NM173 Waterline Relocation  
Design, Bid and Construction Services  
RFP # 2020-728

Addendum #1  
December 23, 2019

NOTICE TO RESPONDENTS

Response to questions received as of December 23, 2019, 9:00 AM

**NM 173 Water Line Project  
City of Aztec**

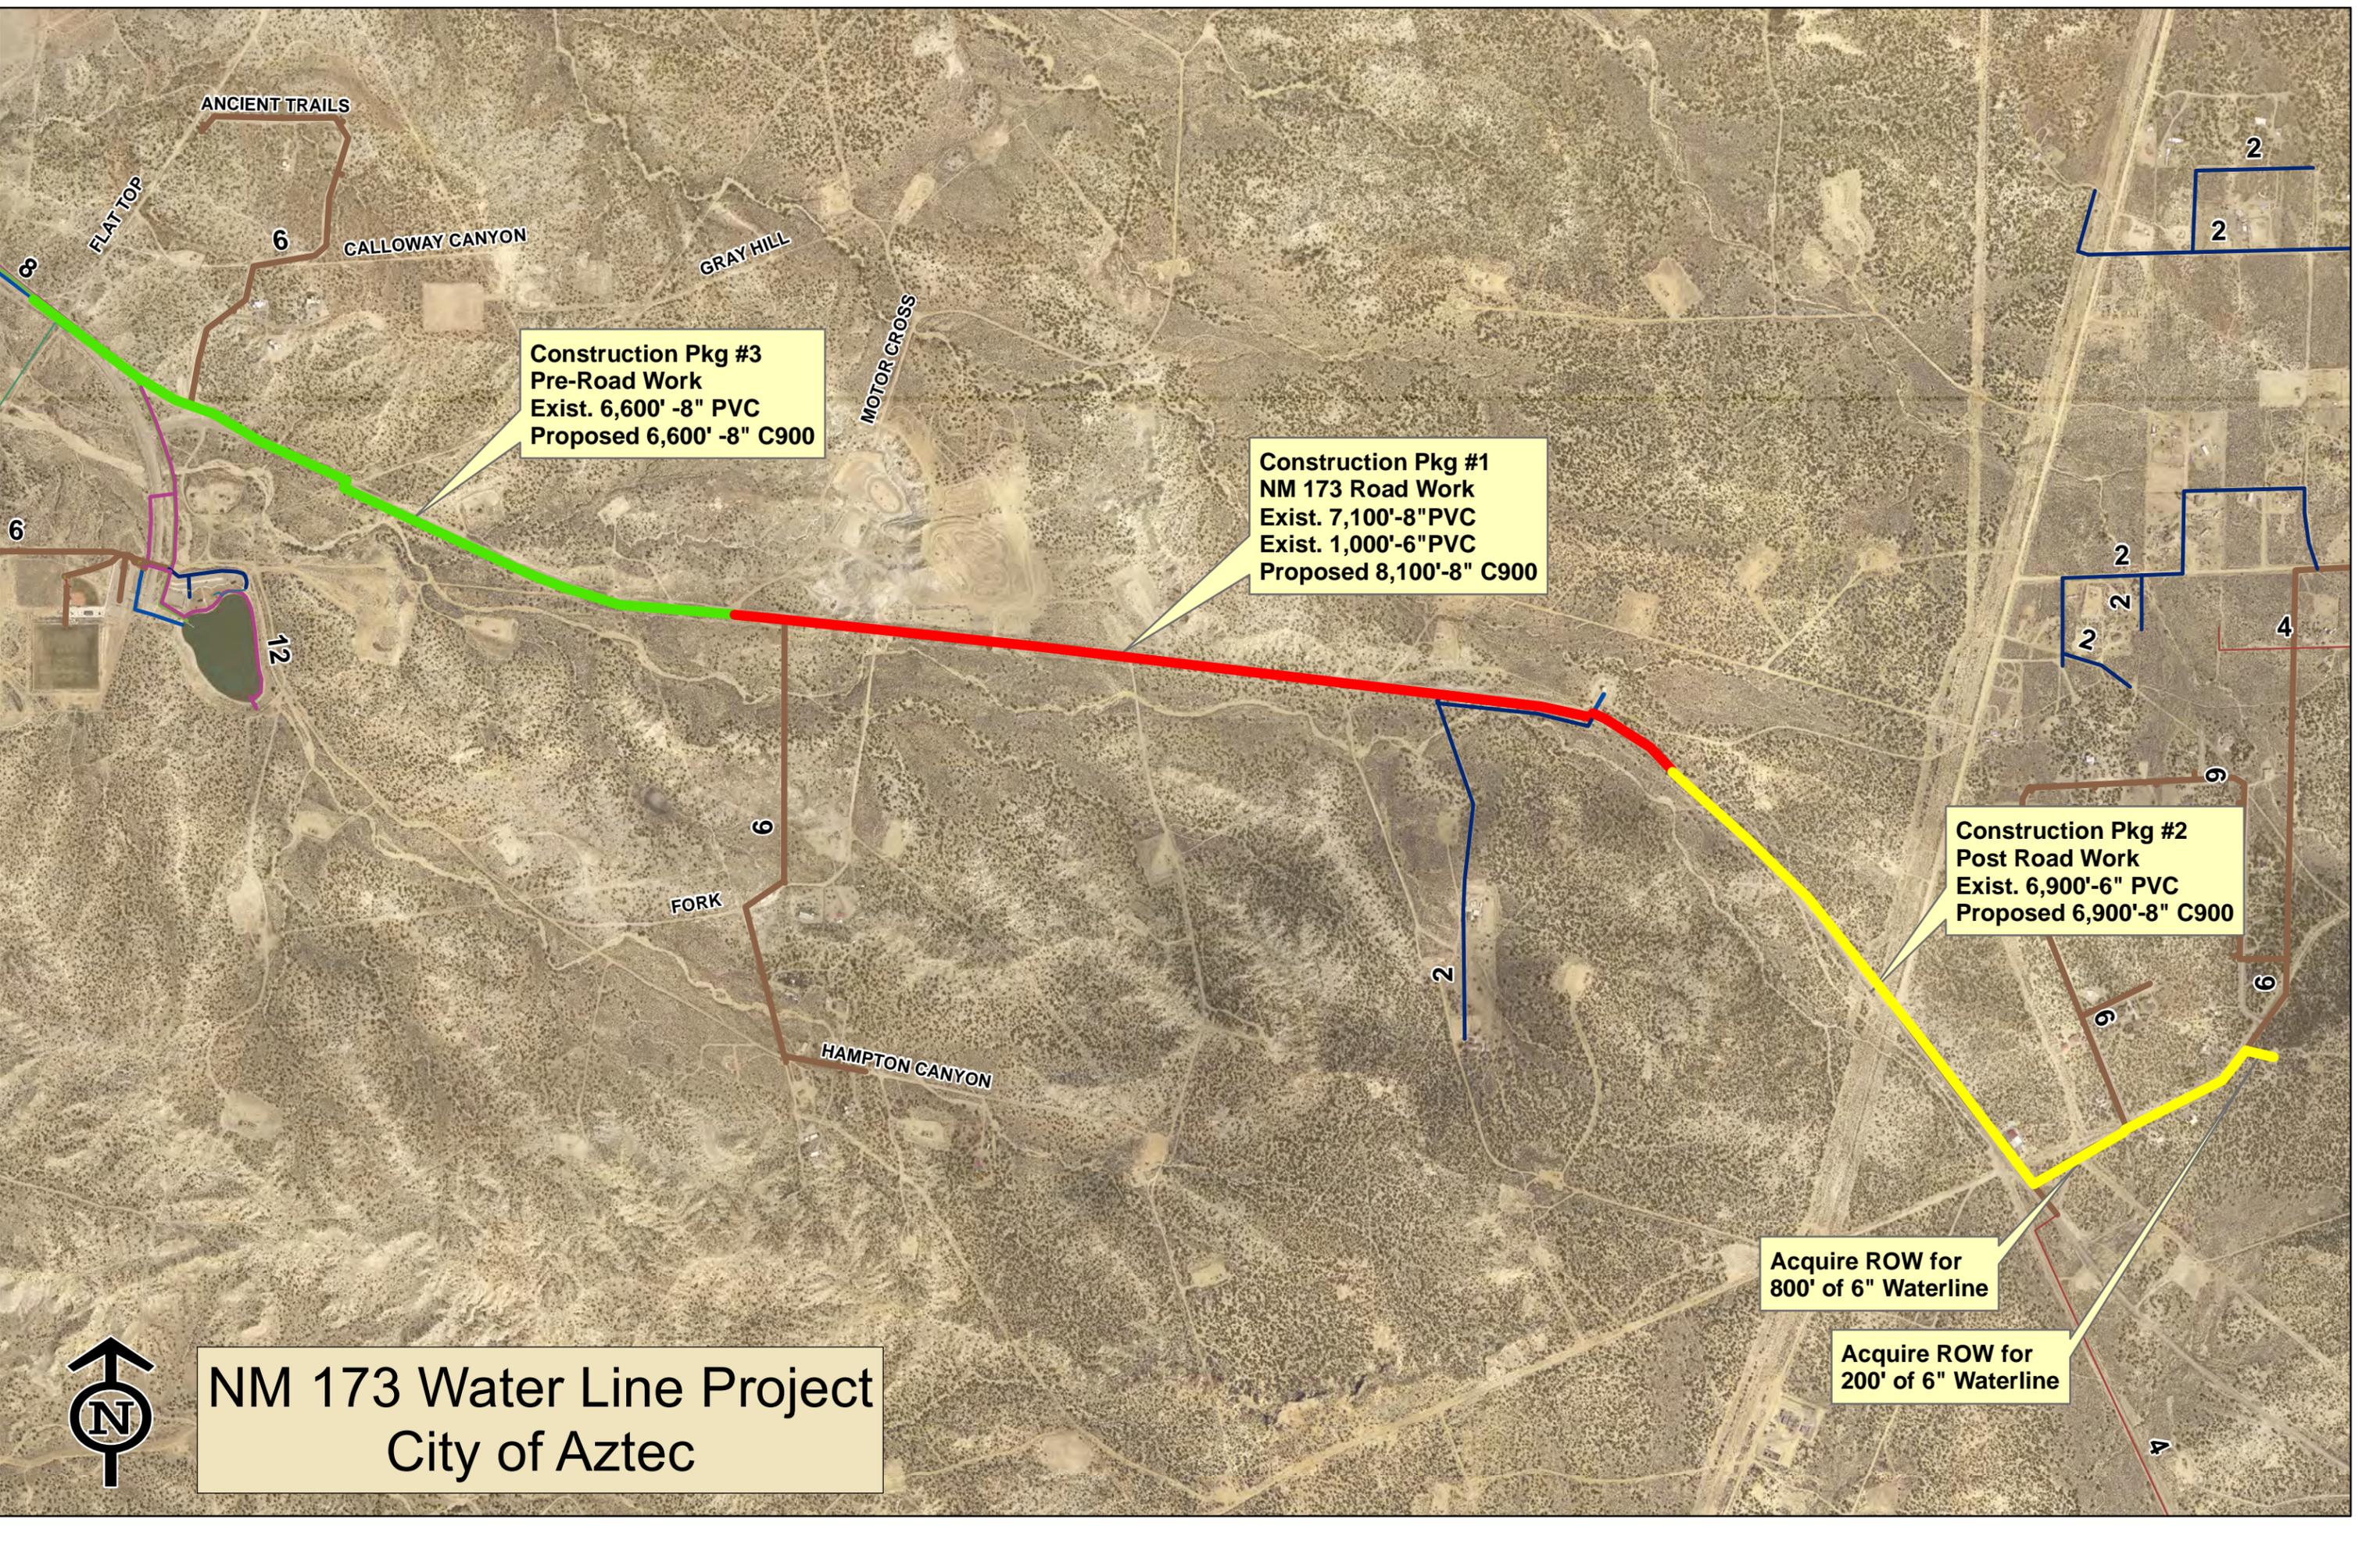
*The revised GIS map is included with this addendum.*
